Title & Document Type: HP 339A Operating and Service Manual

Manual Part Number: 00339-90001

MODEL 339A

DISTORTION MEASUREMENT SET

Figure 8-13. Input Attenuator and Input Amplifier.
8-13/8-14

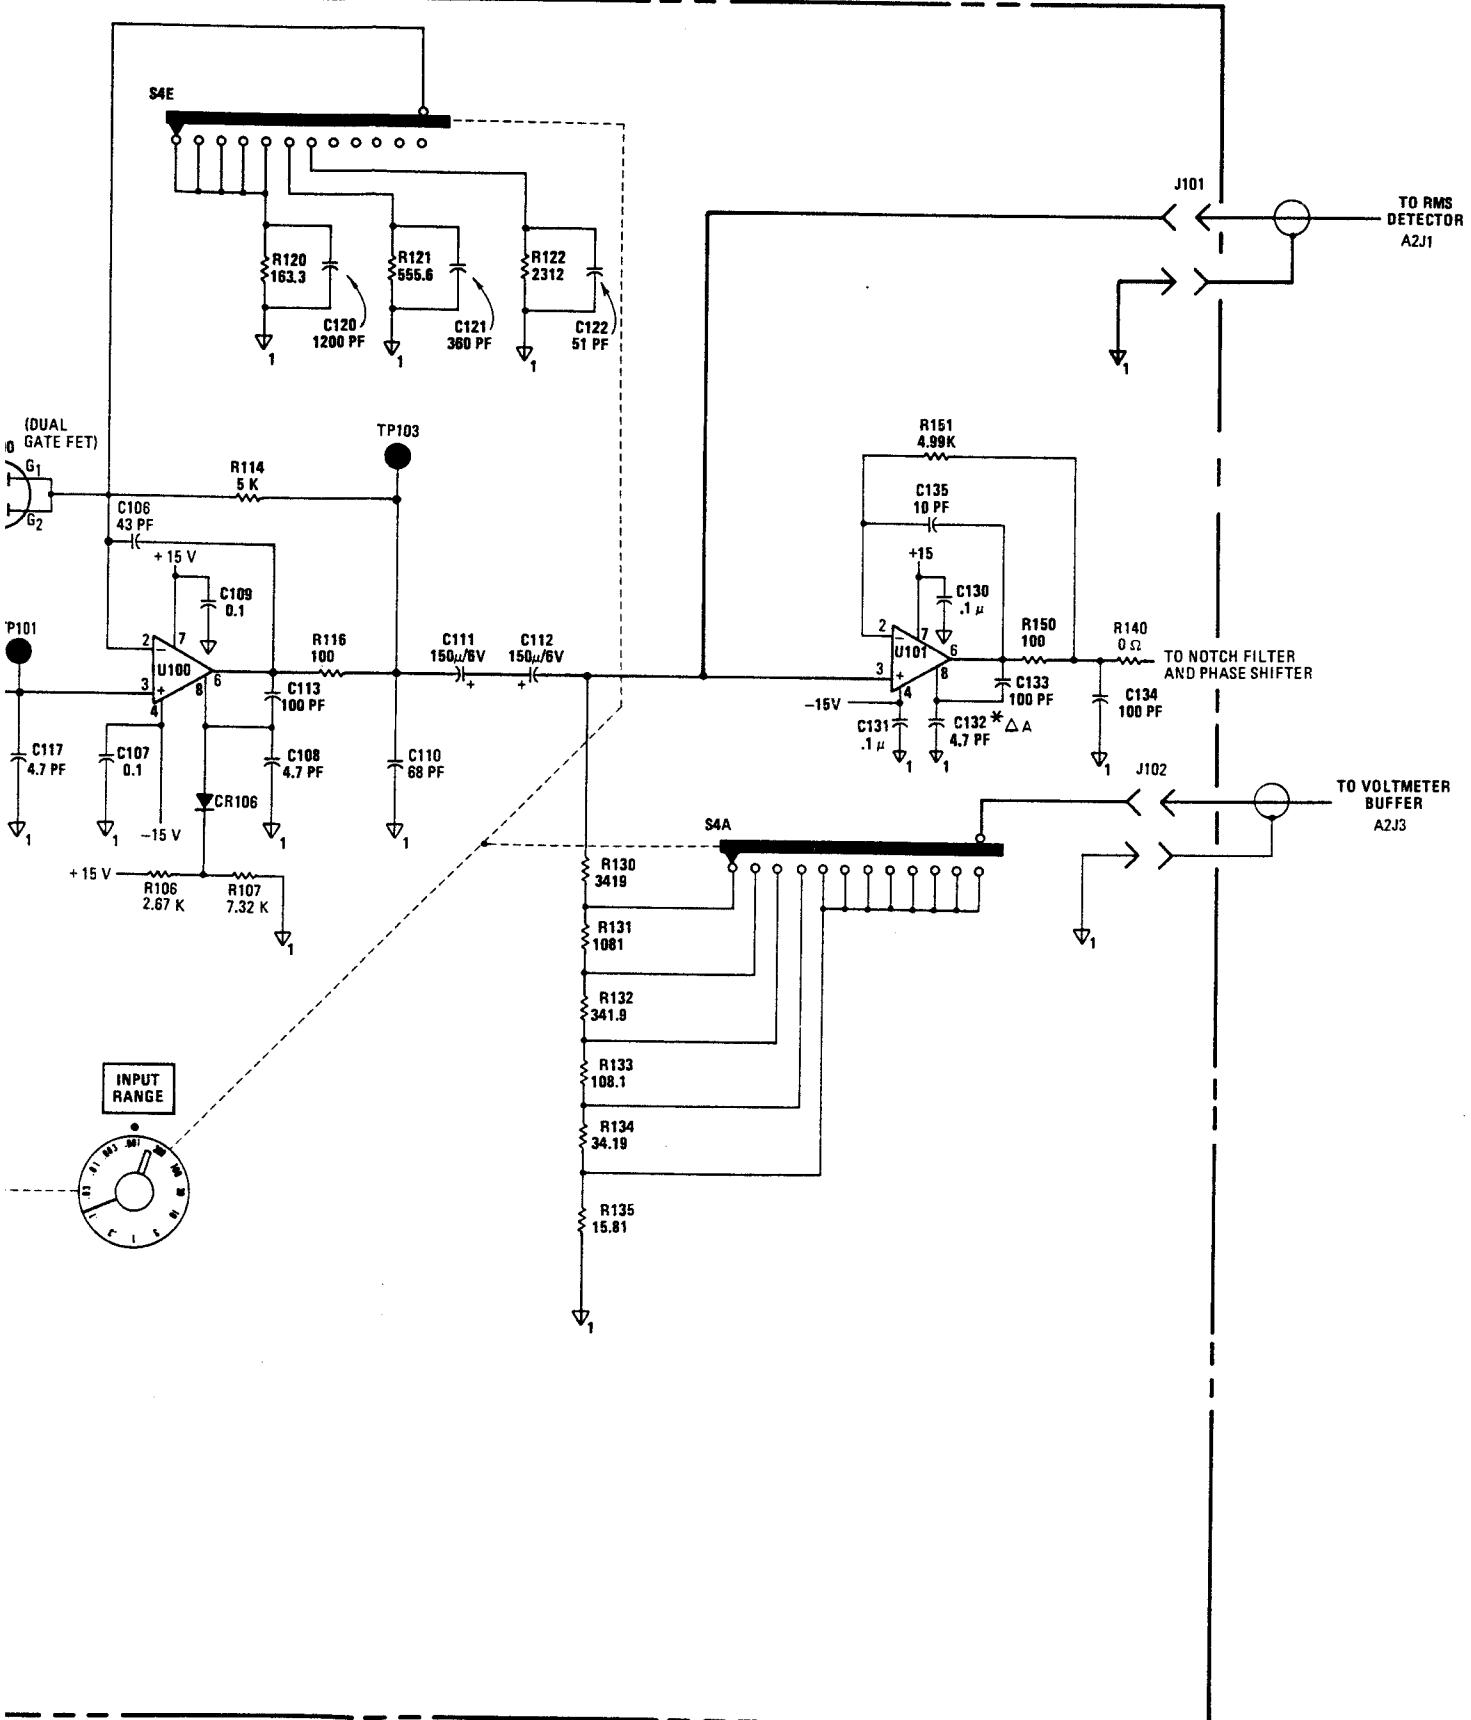
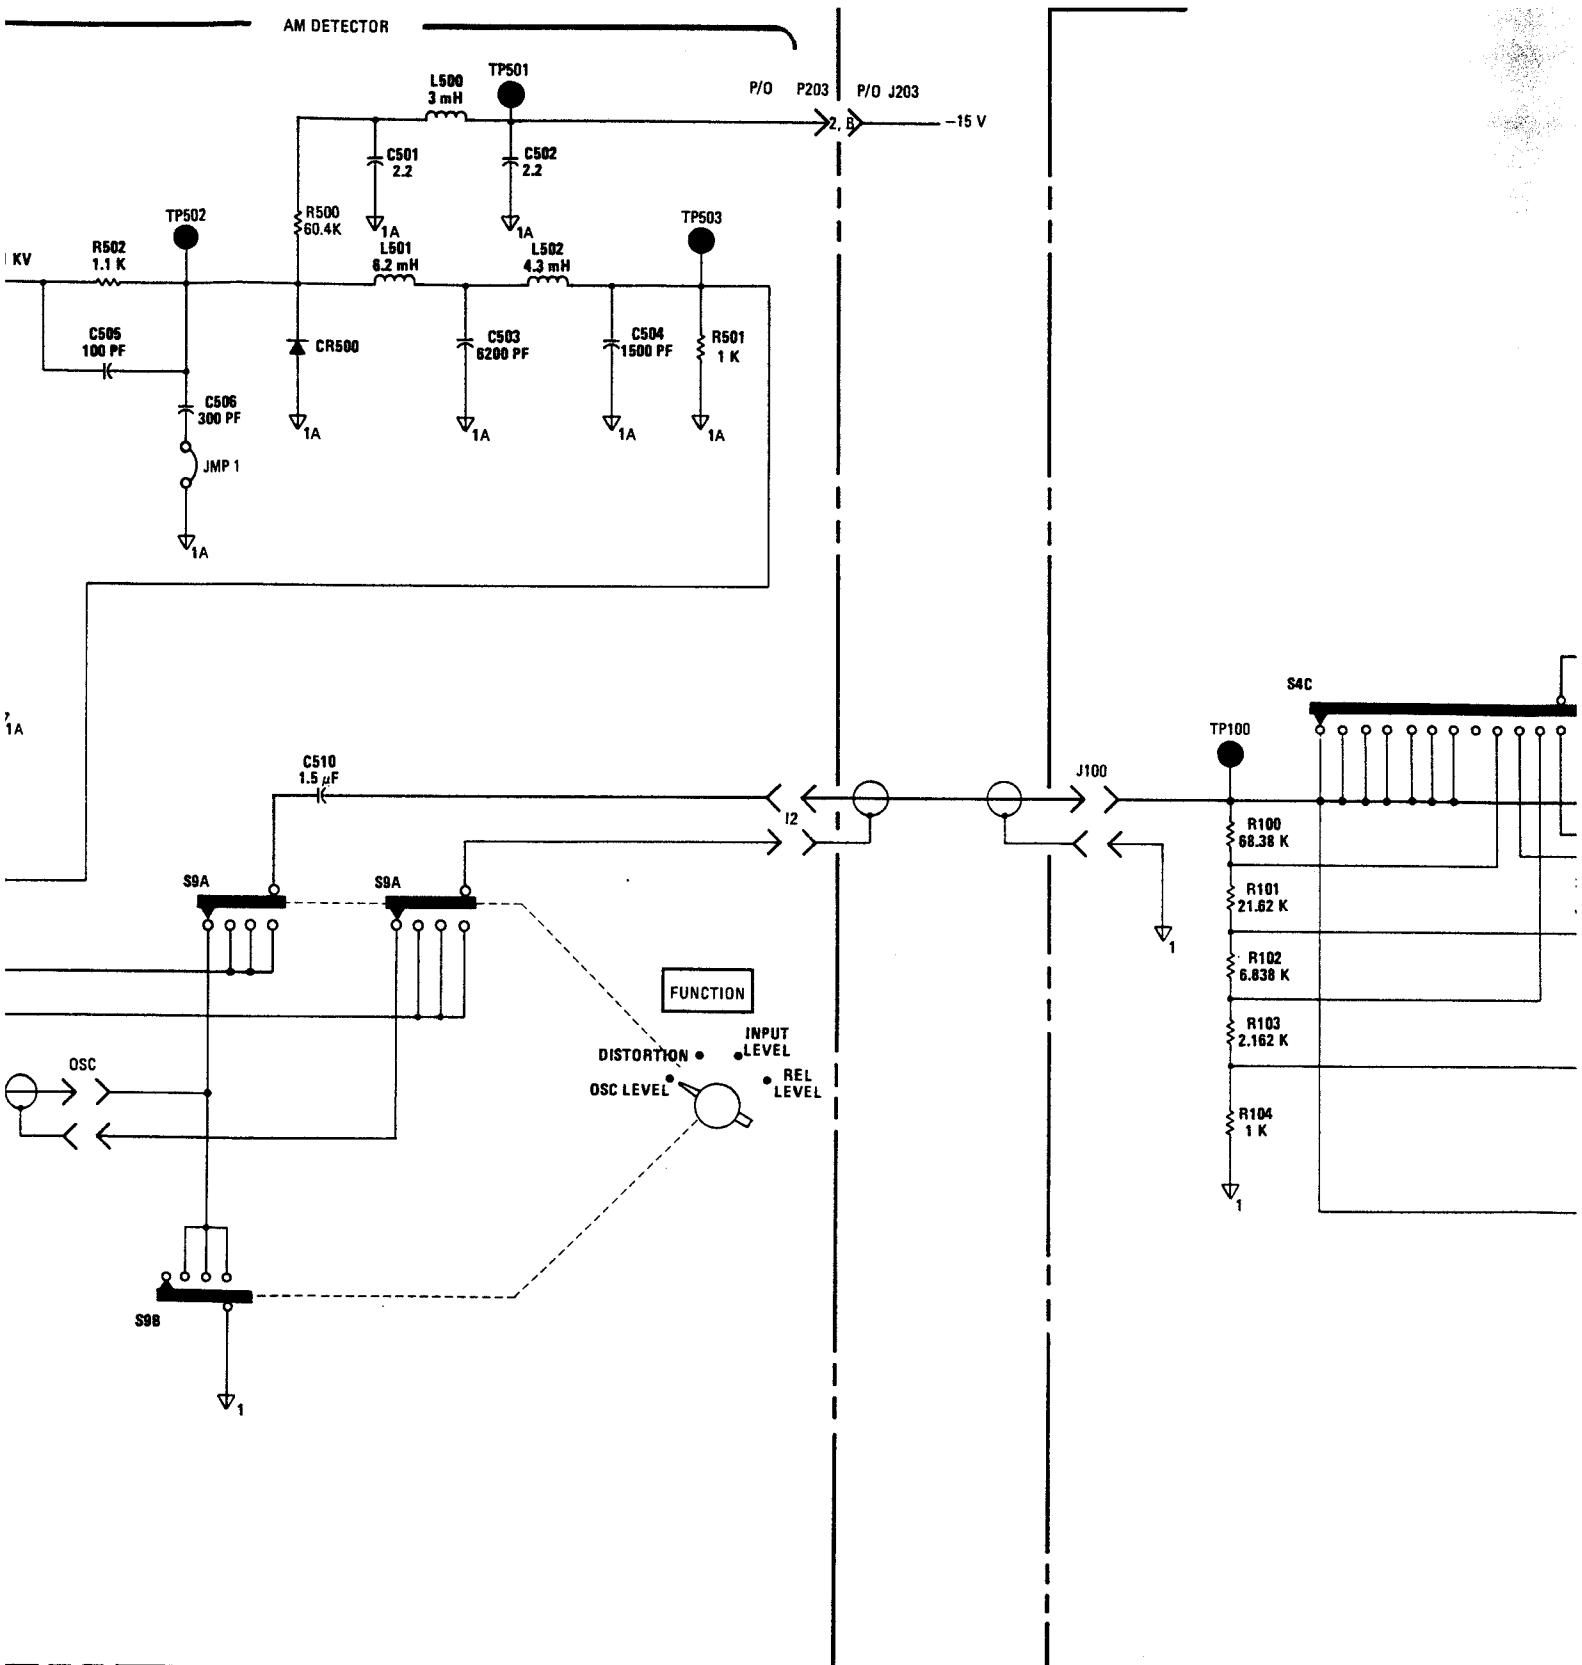
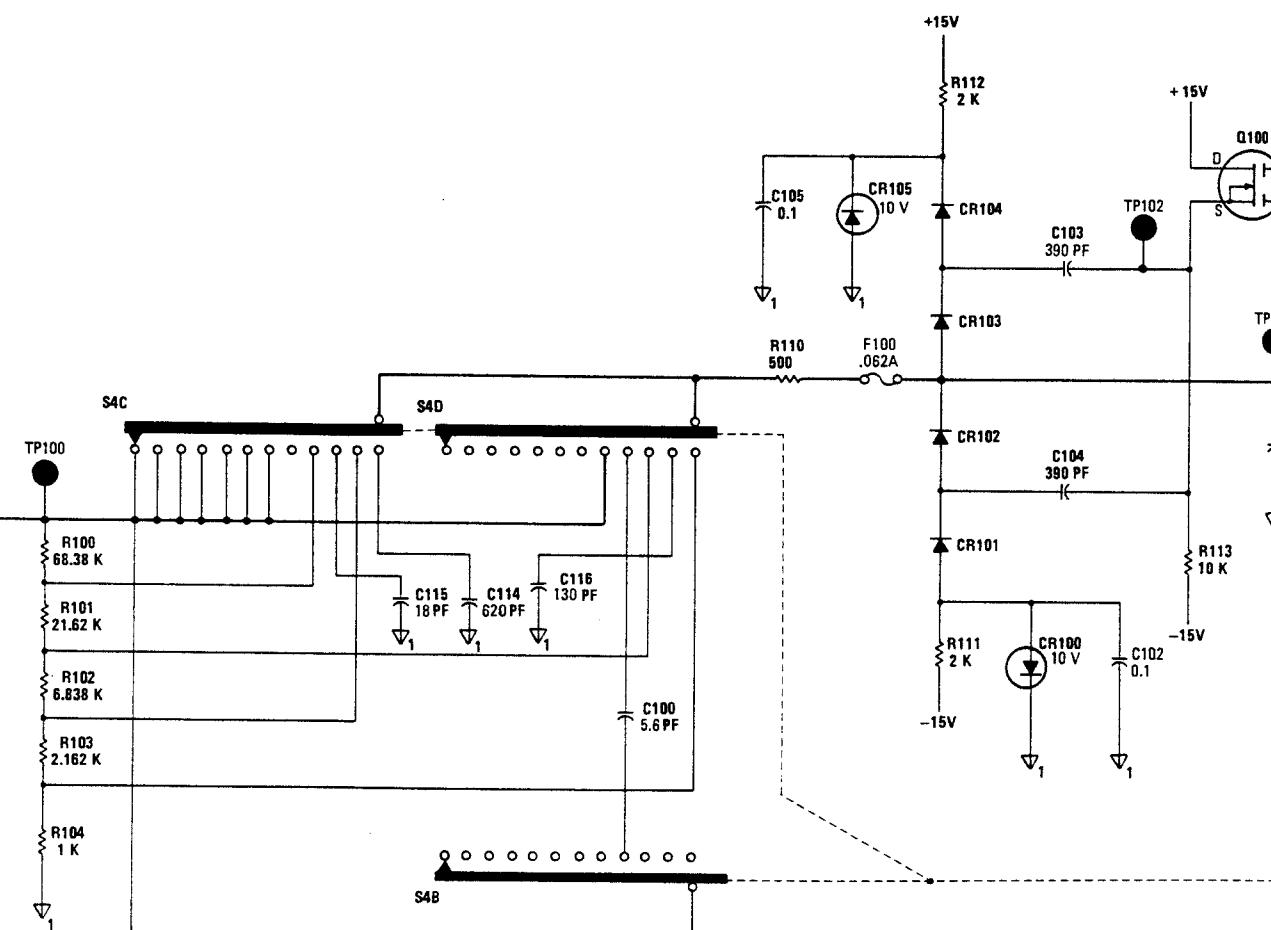
Page 8-13/8-14, Figure 8-13. Change R113 to *R113 and change the nominal value from 10 k Ω to 30.1 k Ω on the schematic diagram.

Page 8-13/8-14, Figure 8-13. Change the schematic value of C114 from 620pF to 360pF.

Page 8-13/8-14, Figure 8-13. Change the schematic value of C114 from 360pF to 640pF.

Page 8-13/8-14, Figure 8-13. Change the schematic value of C132* from 4.7pF to 10pF.

Page 8-13/8-14, Figure 8-13. Change the value of C100 from 5.6pF to 5pF.

Page 8-13/8-14, Figure 8-13. Change the value of C100 from 5pF to 3pF.

Page 8-13/8-14, Figure 8-13. Change the value of C115 from 18pF to 39pF and of C116 from 130pF to 220pF.

Page 8-13/8-14, Figure 8-13. Change the value of F100 from .062A to .1A.

Page 8-13/8-14, Figure 8-13. Change the value of C110 from 68pF to 39pF.
